PUBLIC HEARING MEMORANDUM

SUBJECT: **Working Session Memo for Petition #160-24** for SPECIAL PERMIT/SITE PLAN APPROVAL to allow retaining walls along the sides and rear of the dwelling exceeding four feet in height within the side setbacks and to exceed Floor Area Ratio at 54-56 Indiana Terrace, Ward 5, Newton Upper Falls, on land known as Section 51 Block 40 Lot 06, containing approximately 7,760 sq. ft. of land in a district zoned Multi Residence 1. Ref: Sec. 7.3.3, 5.4.2.B, 3.2.3, 3.2.10 of Chapter 30 of the City of Newton Rev Zoning Ord, 2017.

54-56 Indiana Terrace

ZONING REVIEW MEMORANDUM

Elevations

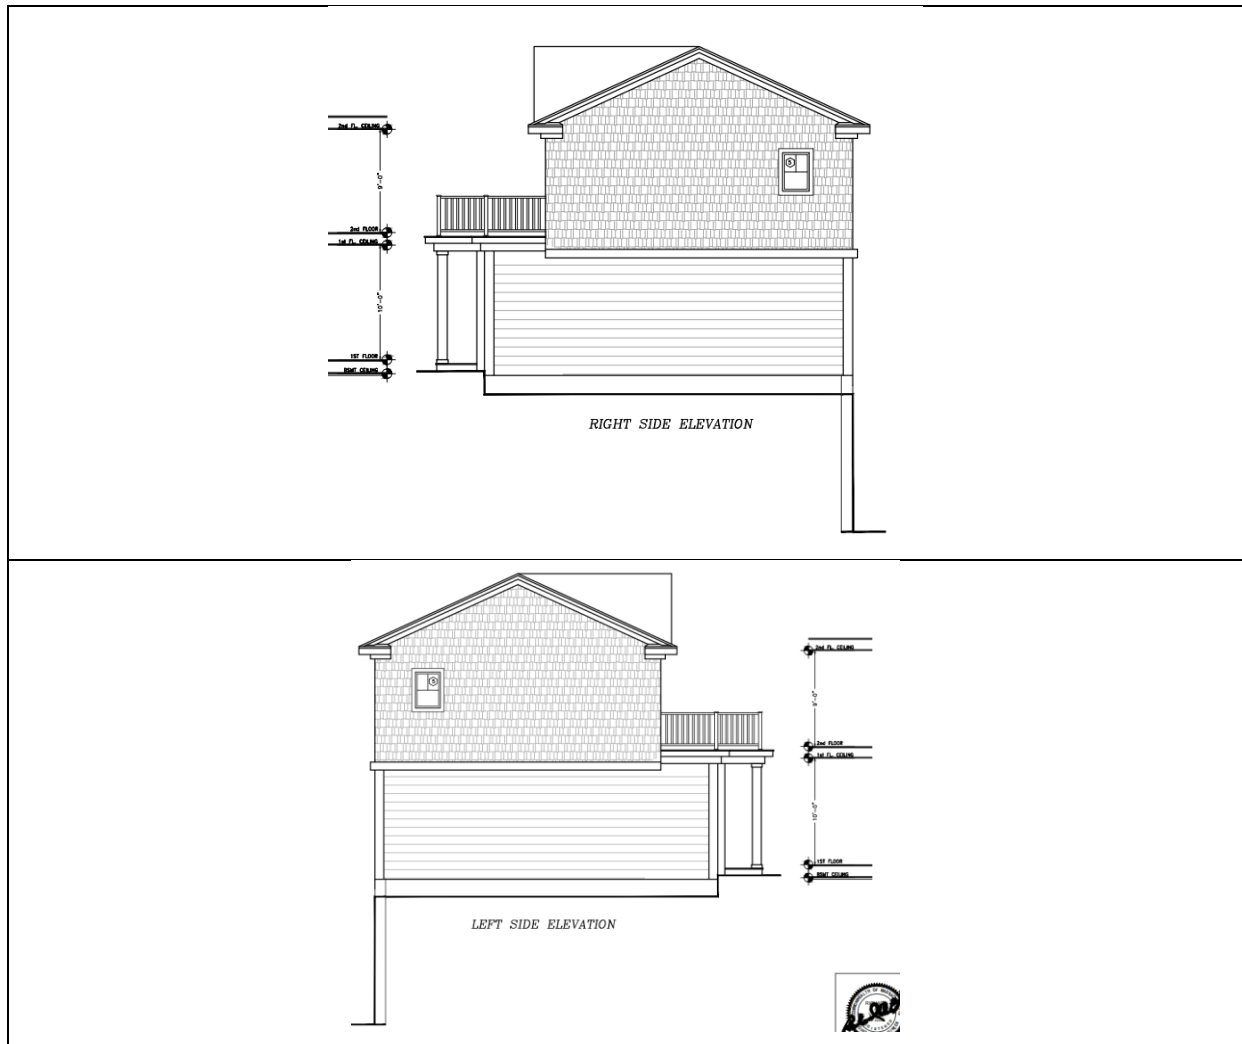
- Changes to the rear and front facades: in addition to changes to the new bays and bringing the front façade and entrances forward, the petitioners have replaced the sloped overhang between the first and second floor on the front façade with a balcony. The last of the changes to the façade of the building are the changes to the second floor front façade, which had previously had two gables that extended from the bottom of the second floor to the roofline. Instead, the petitioners shortened those gables, having them begin at the top of the second floor and extend to the roofline. Two more gables were added towards the side facades with a door and single-window on each side replacing where there have been double-windows.

- Building Height: changes to the overall height of the building are minor with a decrease from 34.26 feet to 34.1 feet despite the lower grade as the overall height of the building from the first finished floor to the roof peak is decreased by one foot.
